NUMBER: 03-007-16

GROUP: Differential &
Driveline

Front Of Vehicle Lateral Vibration During Low Speed Acceleration

This bulletin involves replacing both front half shafts.

Fig. 1 Axle Half Shaft Identification

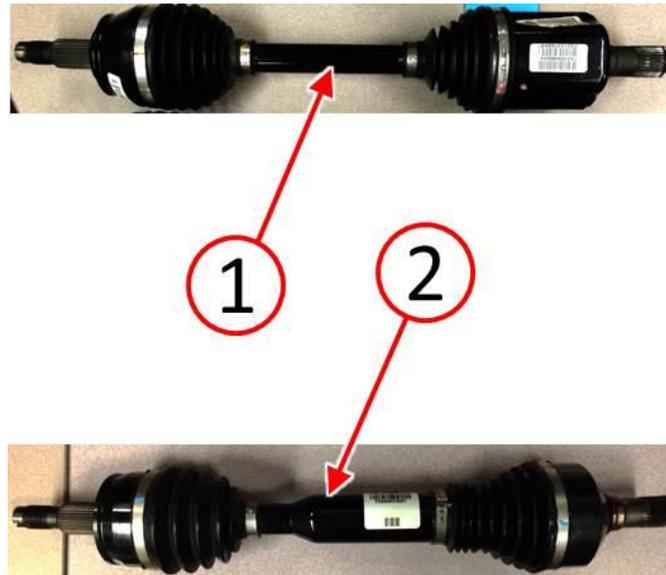
1. Inspect the front axle half shafts to identify which type is currently installed in the vehicle. Refer to (Fig. 1).
 - a. Straight Diameter Center Shaft (Fig. 1)>>> Continue with the Repair Procedure Step #2.
 - b. Stepped Diameter Center Shaft (Fig. 1)>>> This Bulletin does not apply. Normal diagnosis should be performed.

2. Remove the front half shafts with straight diameter center shaft and replace with the stepped diameter center shaft half shafts listed in this bulletin. Refer to the detailed service procedures available in DealerCONNECT> TechCONNECT under: Service Info> 03 - Differential and Driveline> Half Shaft, Front> Removal/Installation.
